Temporary Actions for :

(A) : Cause of failure of C59 & C60

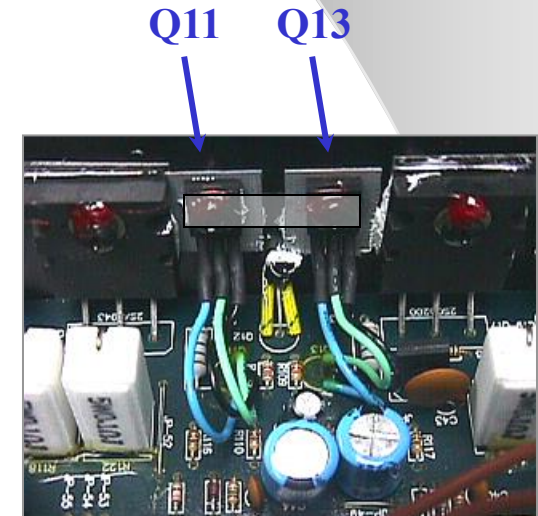
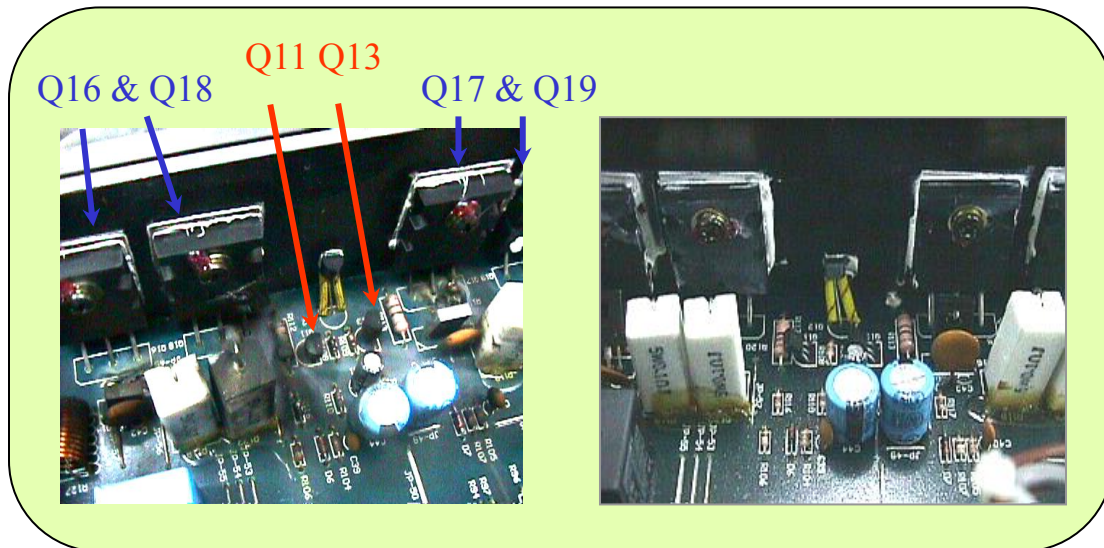
(B) : Cause of failure of Temperature Compensation of Power Transistors

(C) : Cause of failure of Resistors 143 and 144

- (1) Temperature rating of C59 & C60 to be changed from 85°C to 105°C as temperature of the capacitor is found to be 89°C during Evaluation. Capacitance will be the same (12000uF , working voltage 63 VDC)

- (2) Q11 is changed from MPSA56 (TO-92) 625mW max to Philips BD140 (TO-220) 1W max and Q13 is changed from MPSA06 (TO-92) 625mW max to Philips BD139 (TO-220) 1W max
- (3) Q11 and Q13 to be mounted onto the heat sink by a metal bracket to have the same temperature as Q16, Q17, Q18 and Q19 so as to restore the temperature compensation function.

- (4) R143/R144 have to be relocated onto the heat sink. This avoids directly heating up the nearby capacitors C59/C60 and help further cooling down the body temperature of R143/R144
